ADDENDUM #2

Reference: Parleys Maintenance Station #234 Improvements
Utah Department of Transportation - Utah
DFCM Project No. 08211900

ADDENDUM NO. 2 to the Contract Documents for the Construction of UDOT Maintenance Station #2434, Parleys Canyon, Utah.

C400

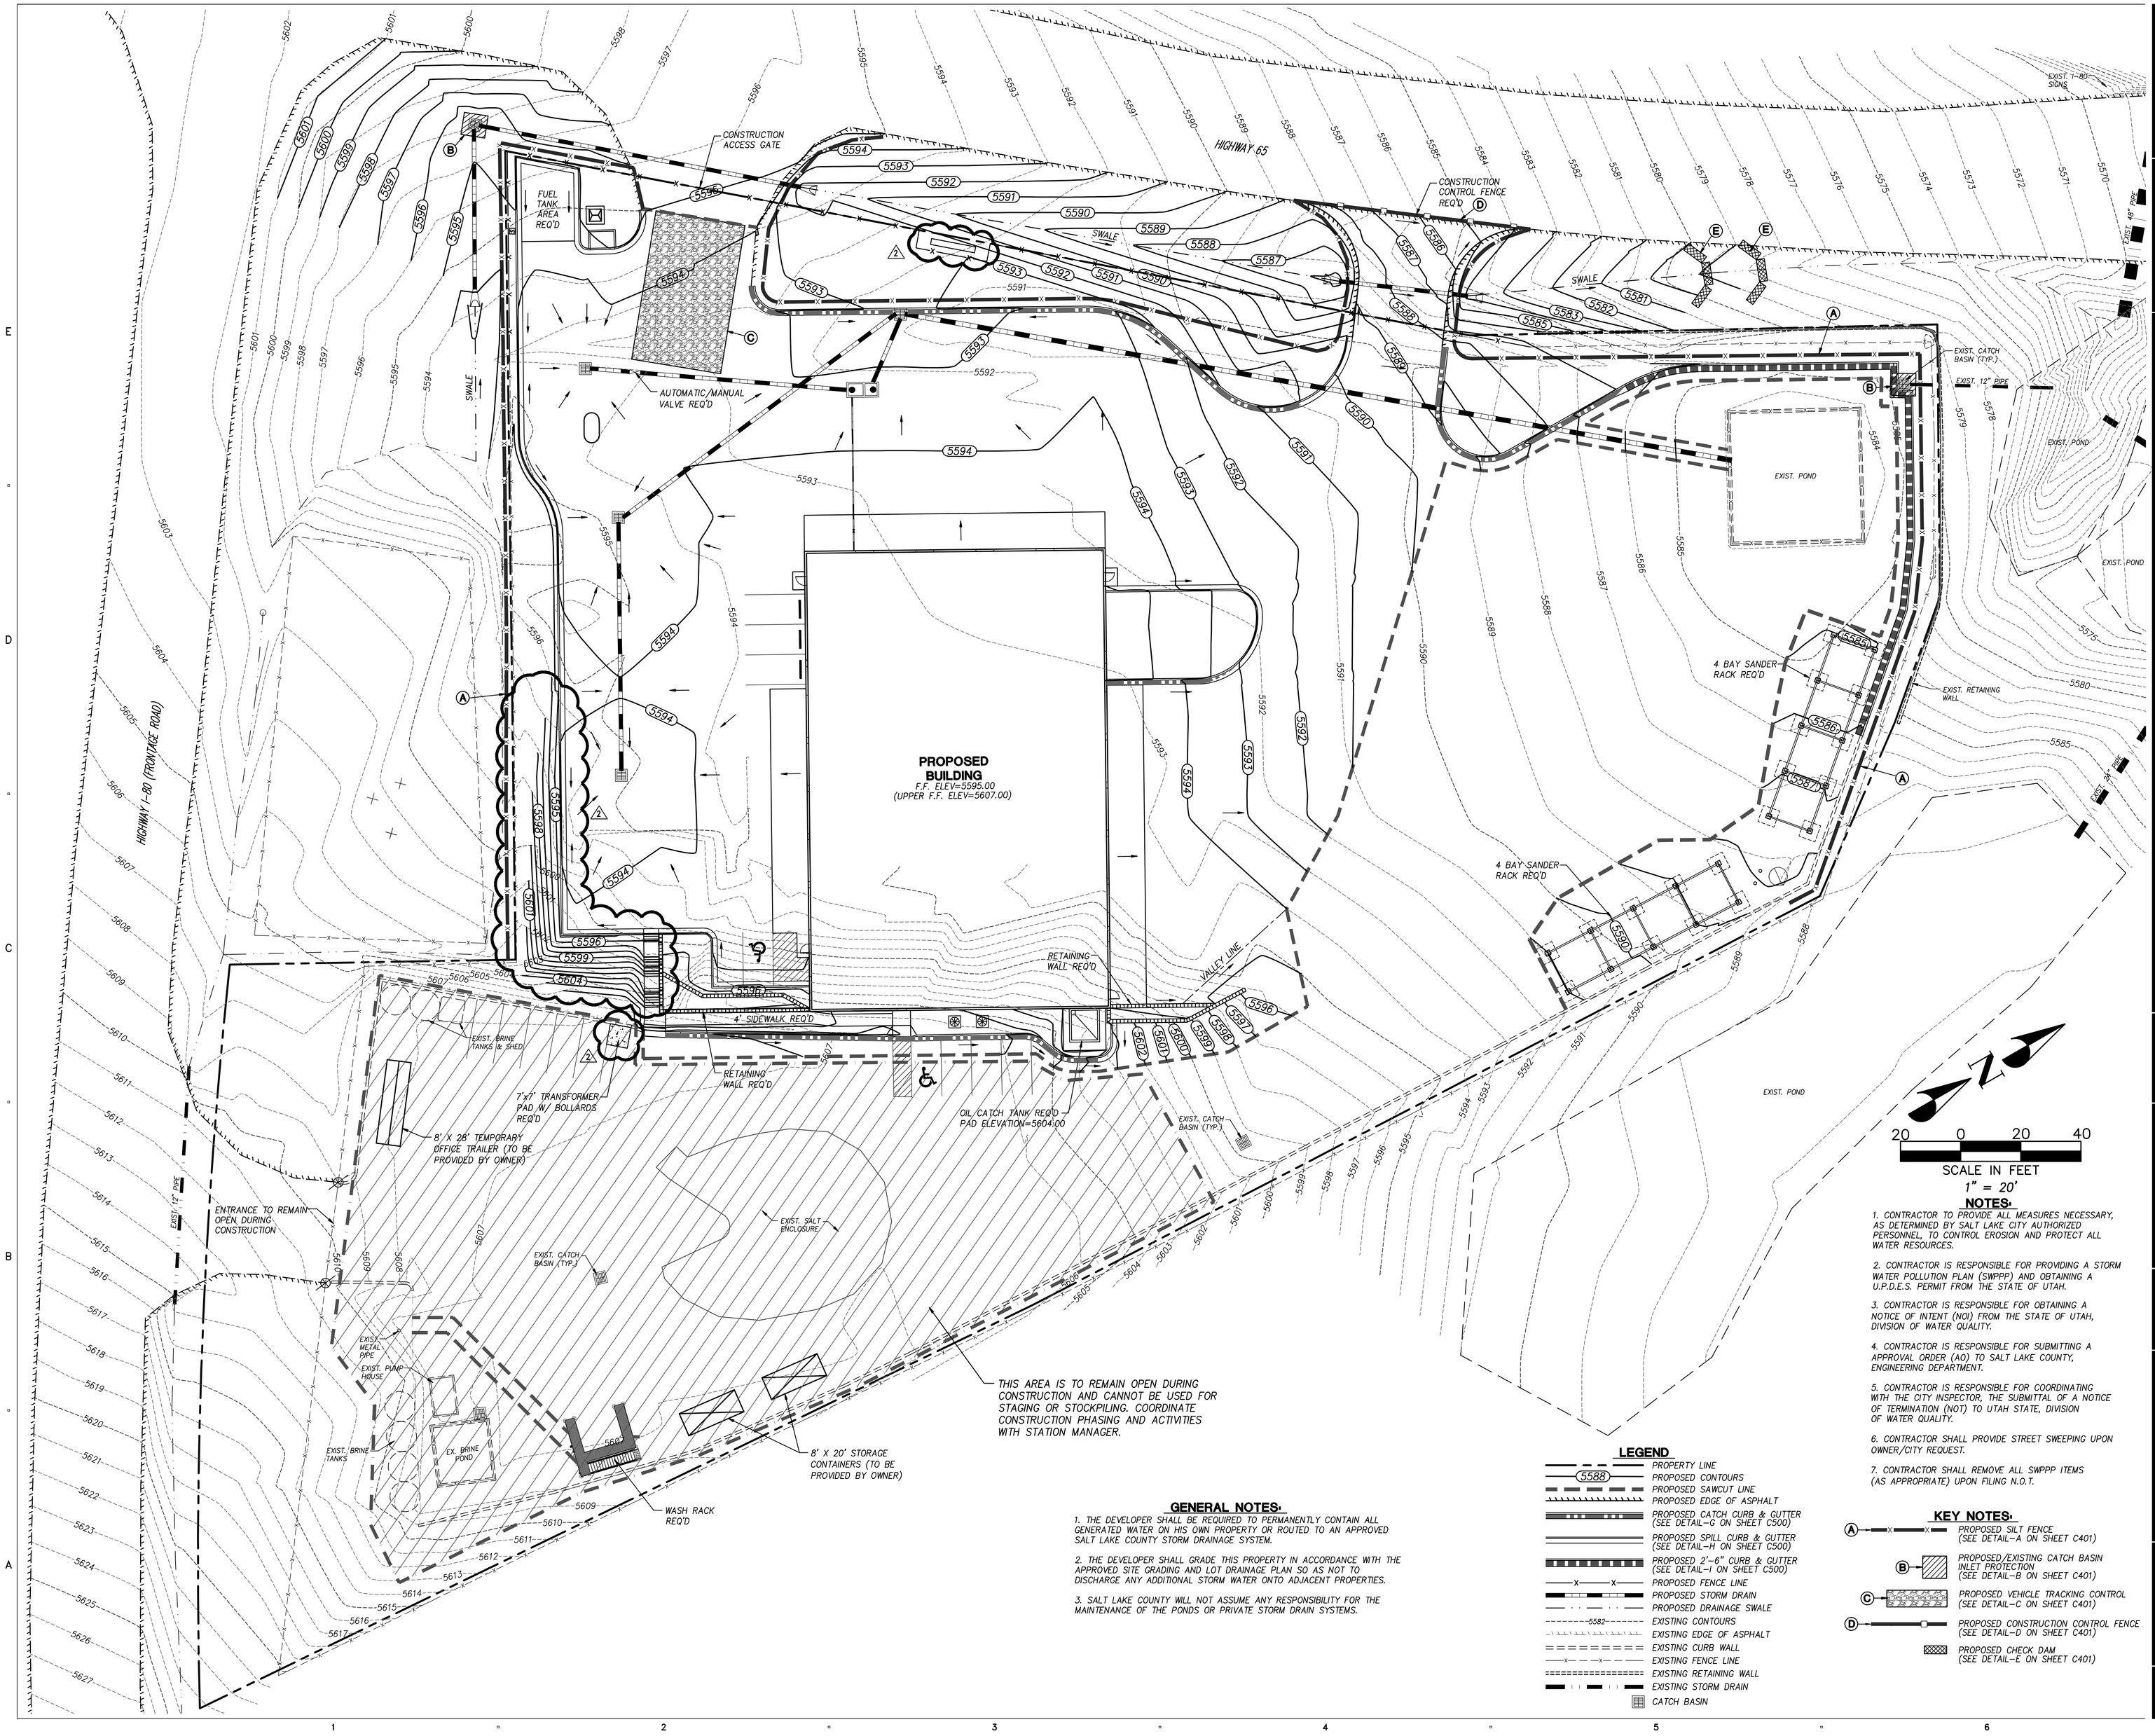
Sheet C400:

a. Relocated new Transformer Pad as shown.
b. Revised grading at hill to south of new concrete stairs as shown.
c. Show relocated monument & fence.

AE101

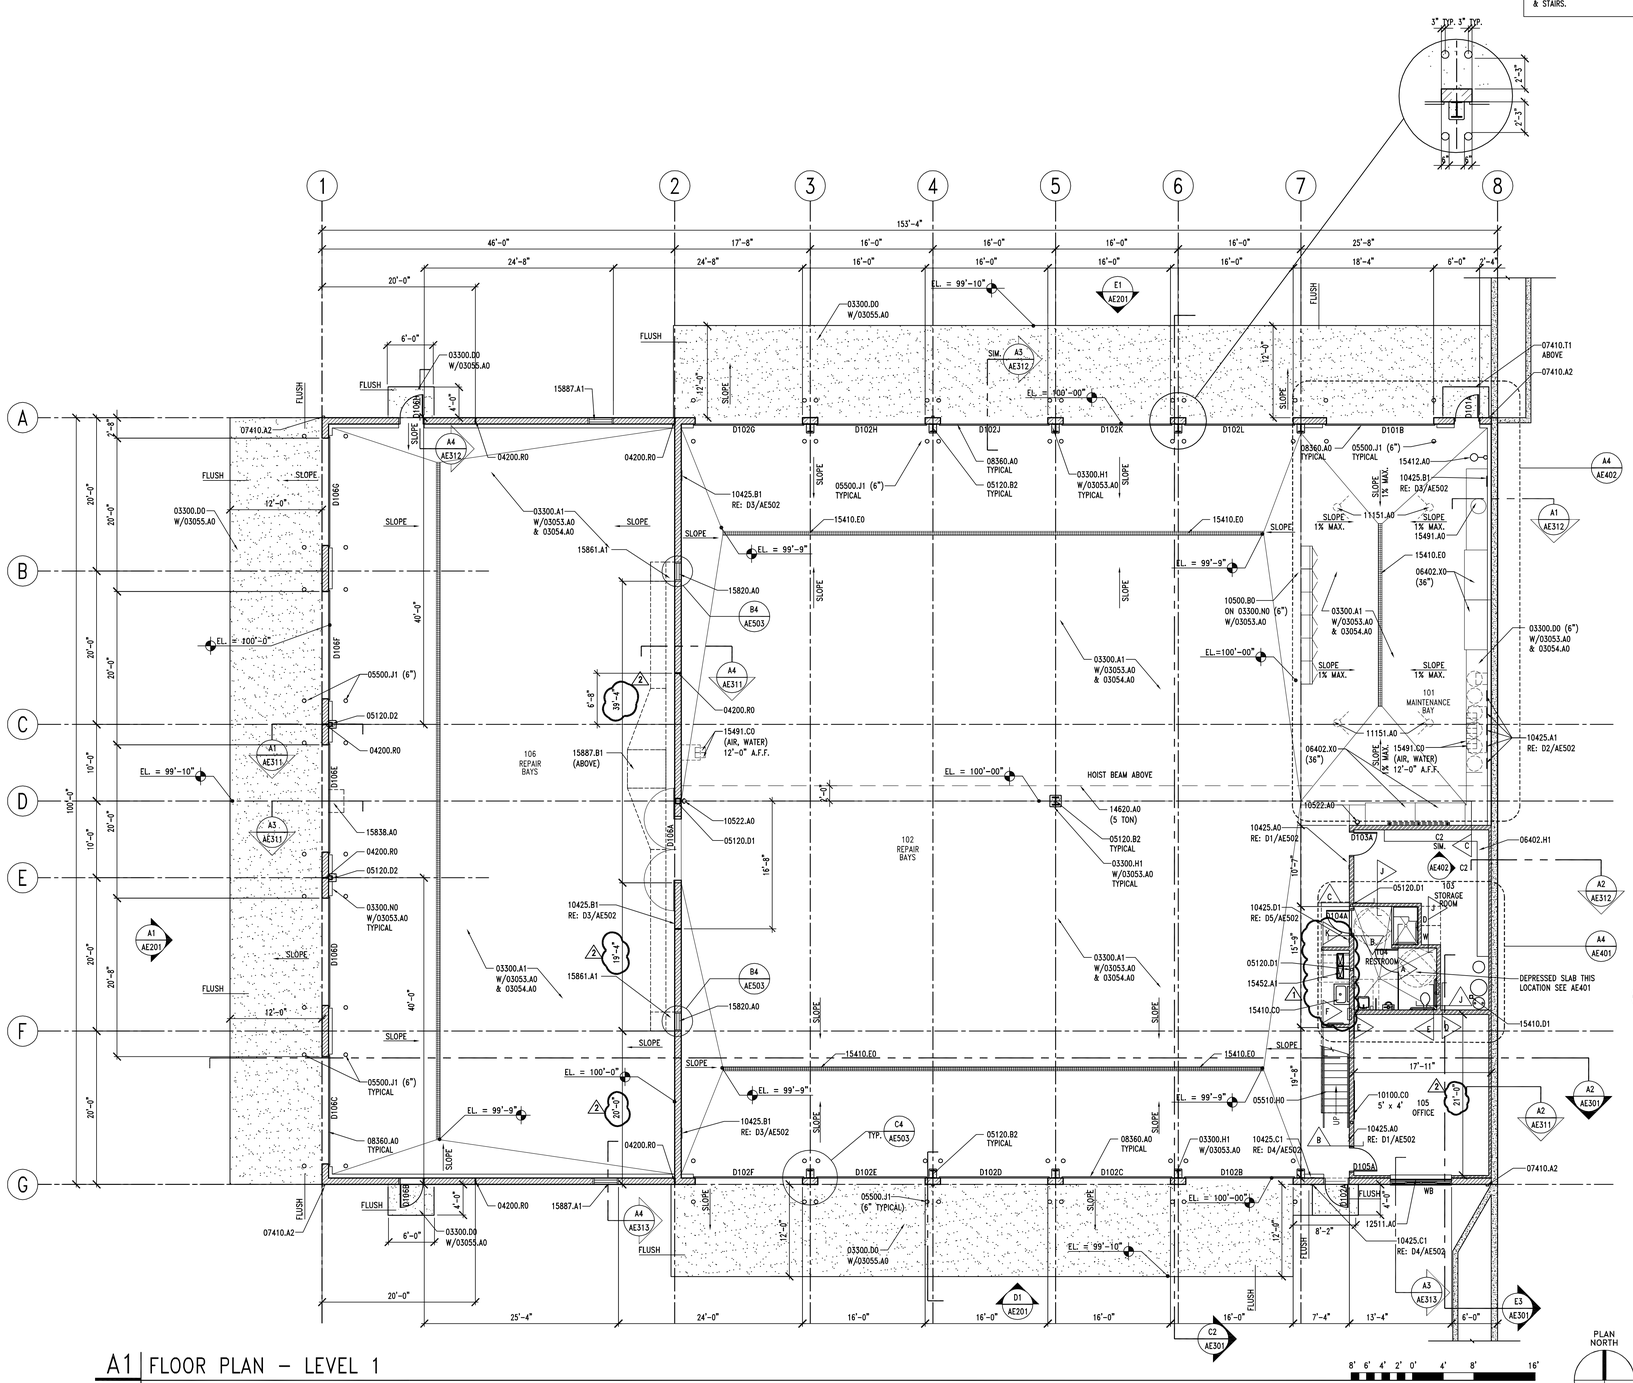
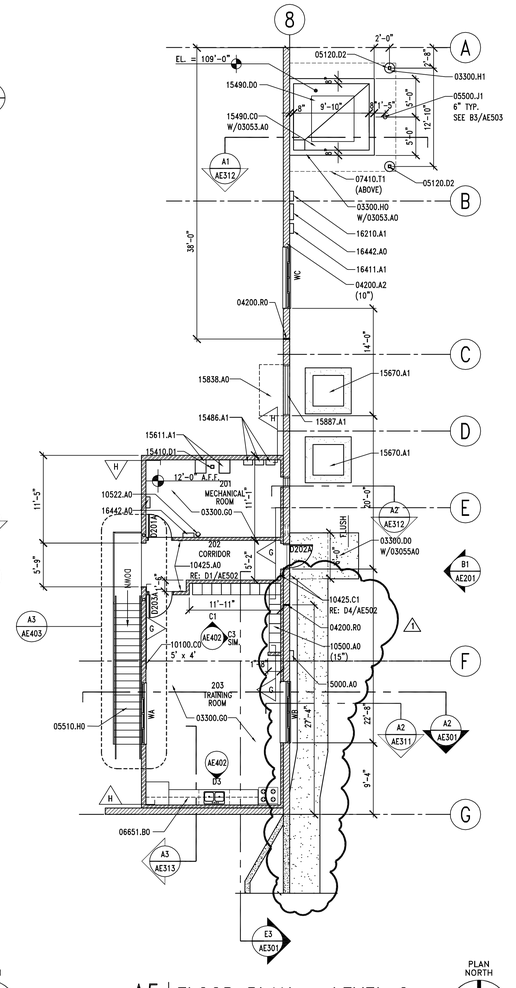
Sheet AE101:

a. Revised dimensions to re-locate mech. dampers.
b. Added Office dimension.

AE311

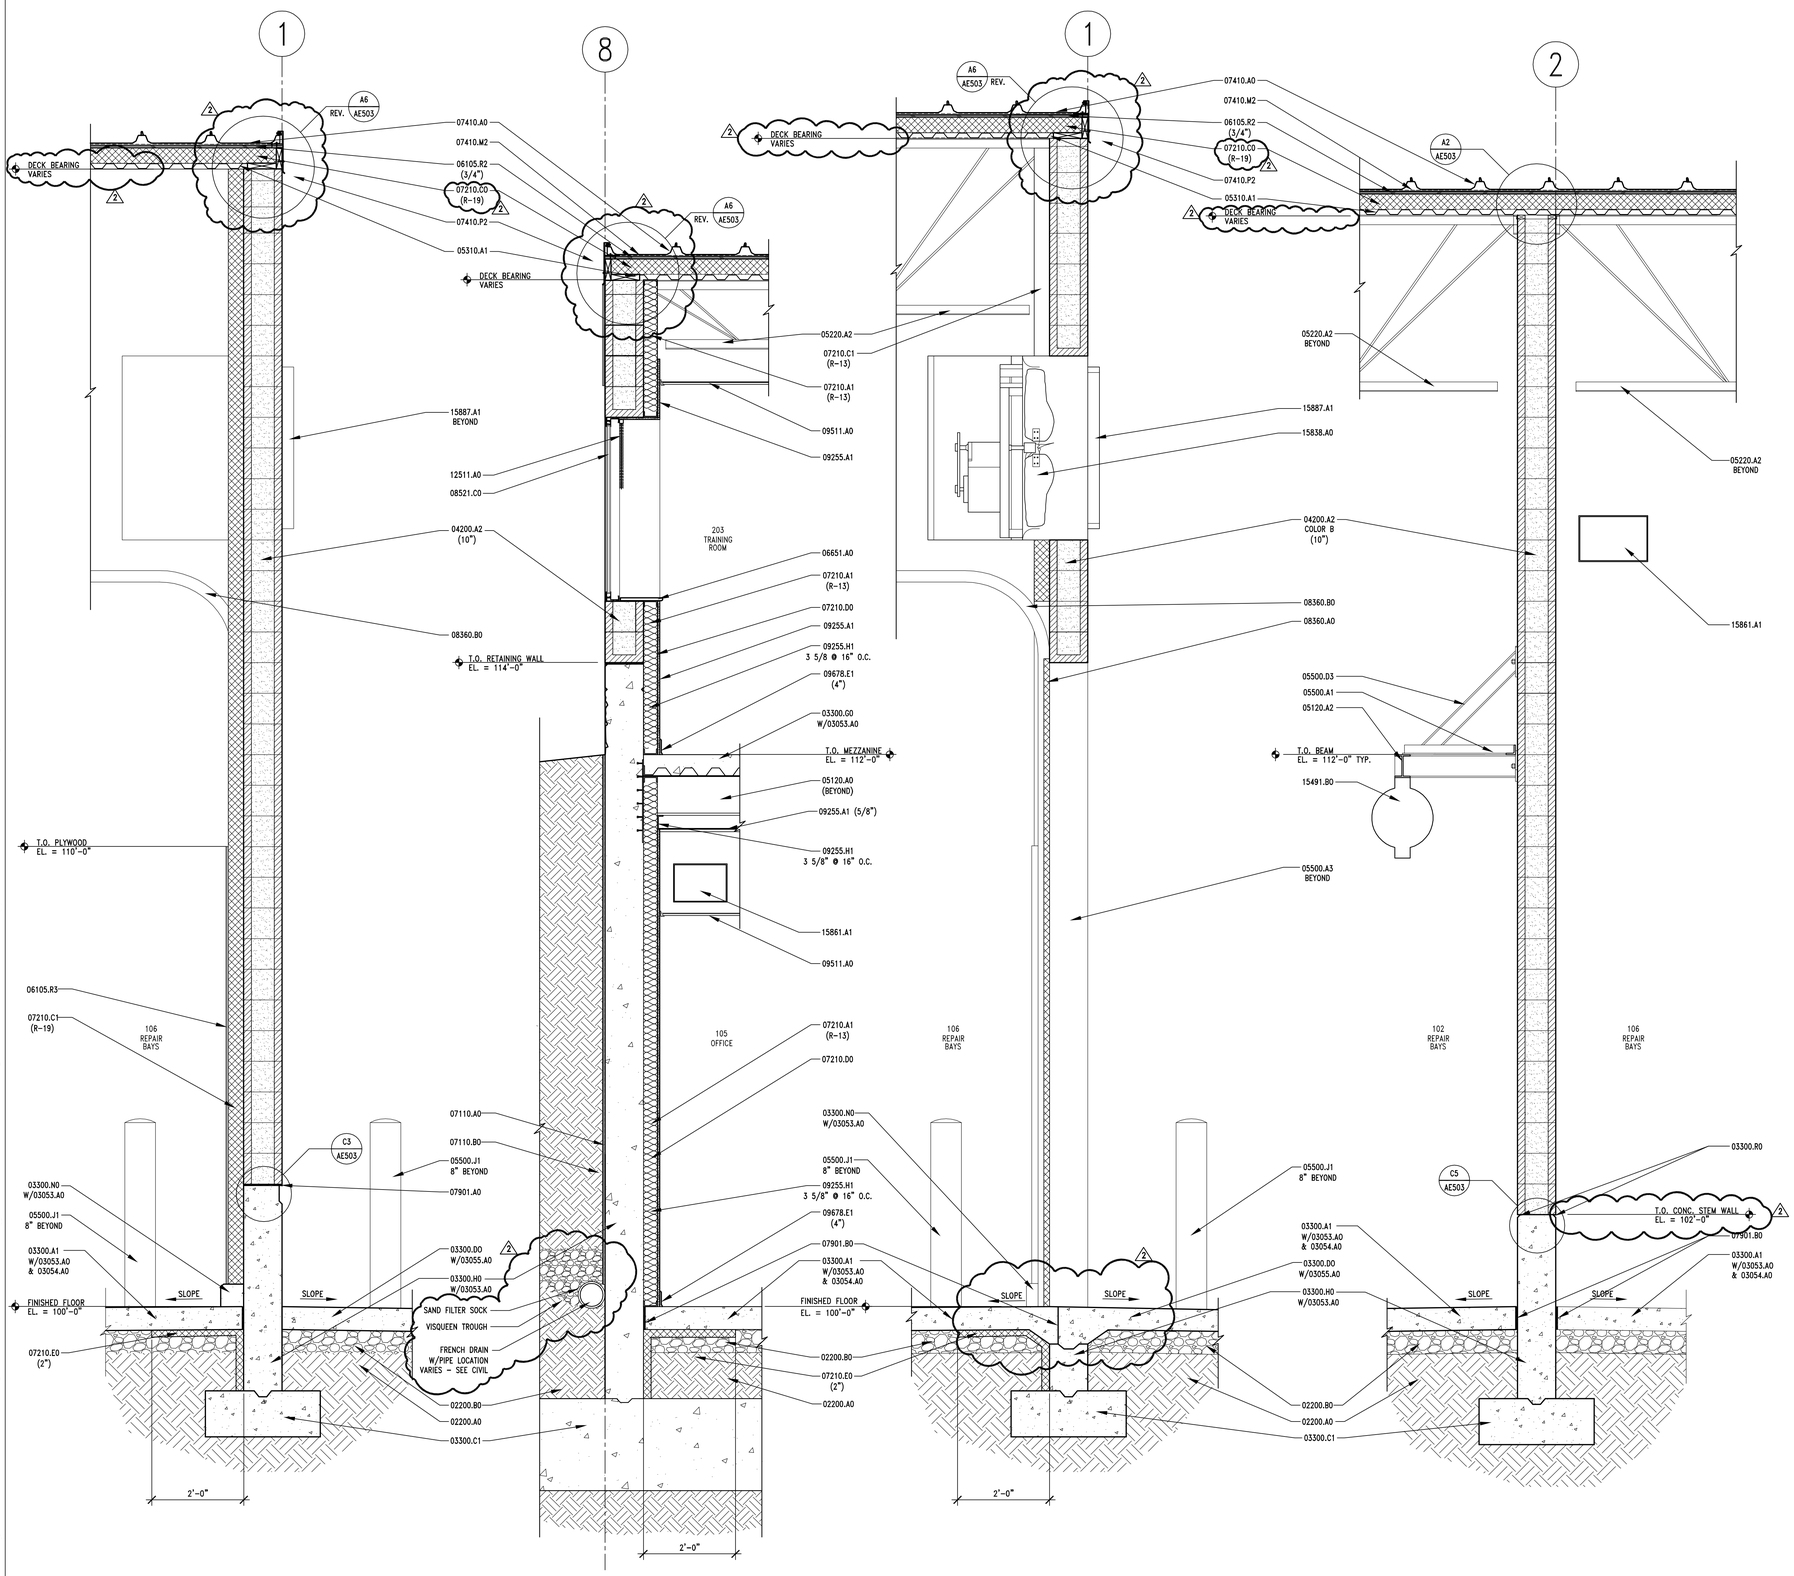
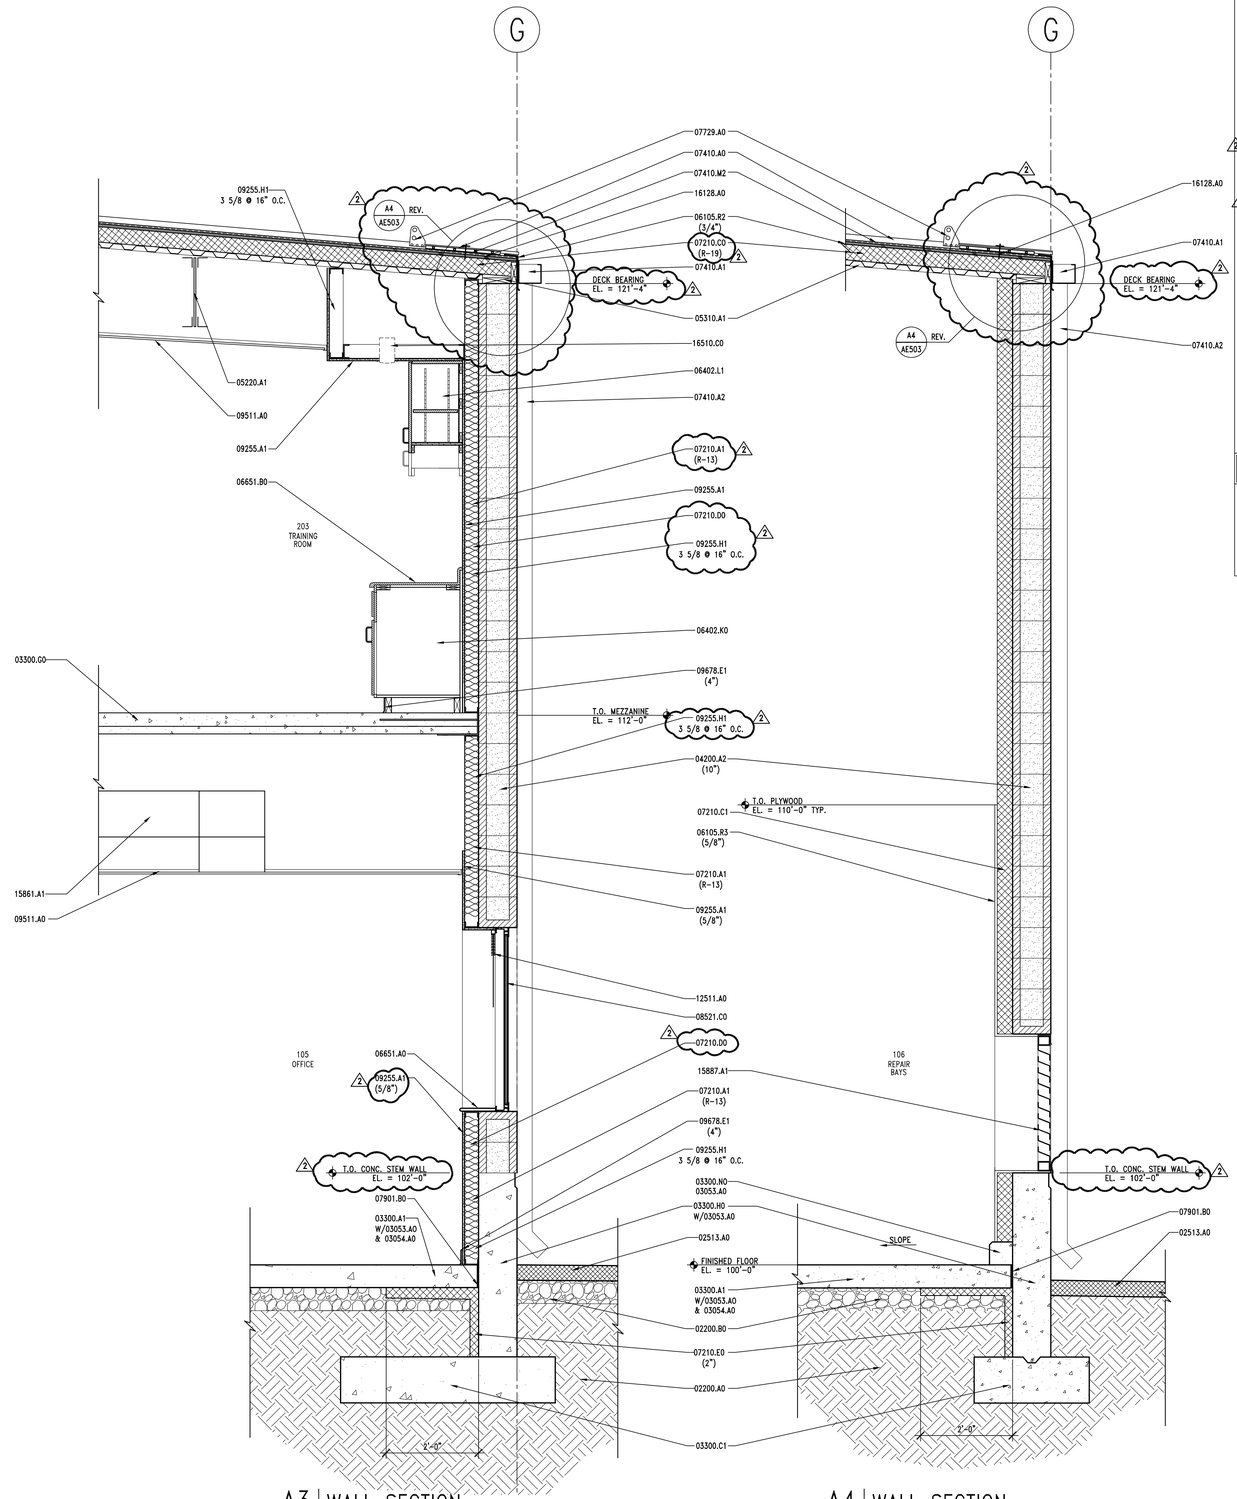
Sheet AE311:

a. Changed Keynote 07210.B1 to 07210.C0.
b. Revised roof edge conditions to match details revised in Addendum #1.
c. Revised french drain in A2 section to coord. with Civil Drawings.
d. Revised slab condition in A3 section to coord. with Structural Drawings.
e. Added deck bearing datum to sections.
f. Show location of textured foundation wall on Section A2.
